Subject Revised Work Plan for Historical Water Supply Well Reconnaissance, Topock Compressor Station, Needles, California

Date April 25th, 2019

Attachment 1
Tabulated Response to Comments

FIGURE 2
Well #1 Historic Map Overlays
 Historical Water Supply Well Reconnaissance
 Pacific Gas and Electric Company Topock Compressor
 Station, Needles, California

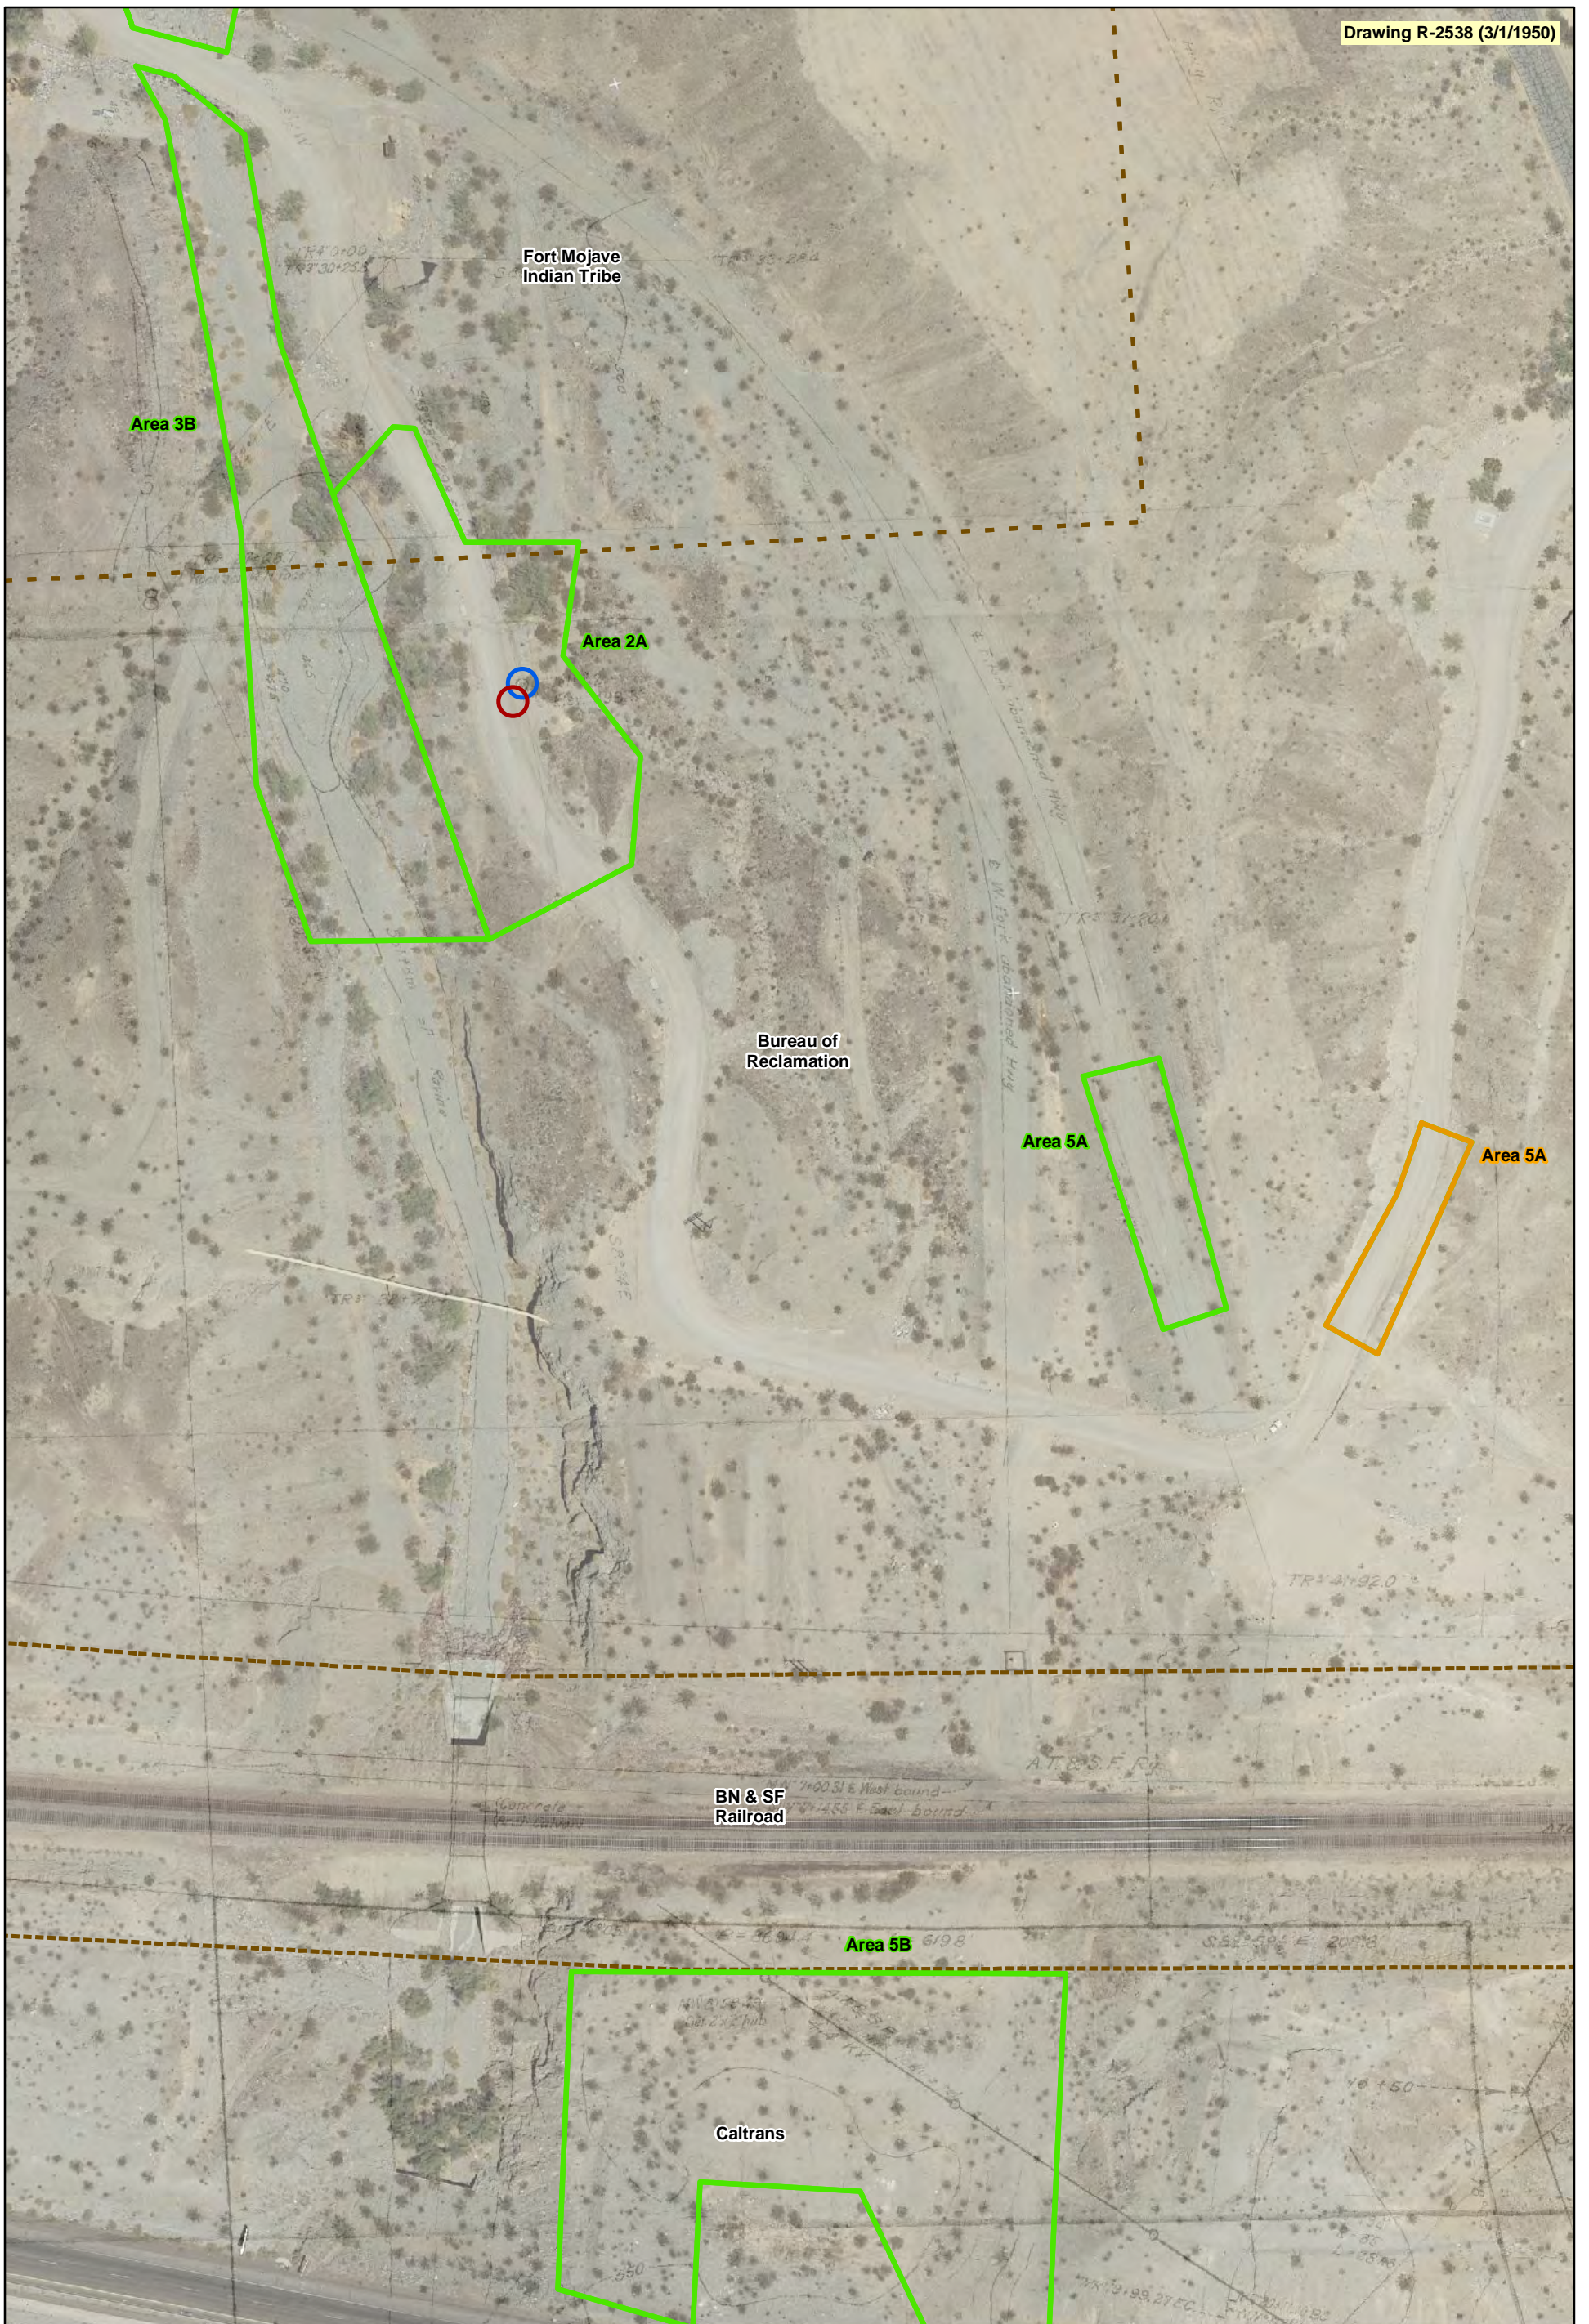
E	<p><u>Page 4, Section 6 Proposed Survey Areas, Well #1 - Area 1A</u>: Figure 2 shows Well #1 located within both the Transwestern facility as well as on PG&E property south of the Transwestern facility. Using image overlays, the GSU independently found Well #1 to be located at the northeast</p>	Drawing 580885 included as an attachment.

<p>corner of the work trailer as pictured on the middle illustration in Figure 2. The middle illustration appears to fit the main access road overlay image best. The GSU did not receive Drawing 580855 as pictured on Figure 2 (only the eastern portion of the drawing was received). DTSC requests that Drawing 580885 be provided electronically.</p>	
<p>F</p>	<p><u>Page 5, Section 6 Proposed Survey Areas, Well #2 - Area 2A:</u> The GSU recommends that handheld magnetic locators also be utilized for locating this well in the immediate area surrounding the circles pictured in Figure 3 as the area is not greatly disturbed and the handheld Schonstedt units used previously at the well TCS-4 area performed quite well in the field. The Recon Work Plan should specify that handheld magnetic locators will be onsite and available for assessing all wells.</p>	<p><u>Section 6.2. Non-intrusive Geophysical Survey</u></p> <p>Paragraph 1, sentence 3 was edited as follows:</p> <p><i>In addition, handheld metal detectors <u>magnetic locators (Schonstedt or equivalent)</u> and other tools may be used.</i></p> <p>Paragraph 3, sentence 1 was edited as follows:</p> <p><i>Second, a preliminary geophysical survey will be conducted using <u>a handheld magnetic locator, a magnetometer, and terrain conductivity methods.</u></i></p>
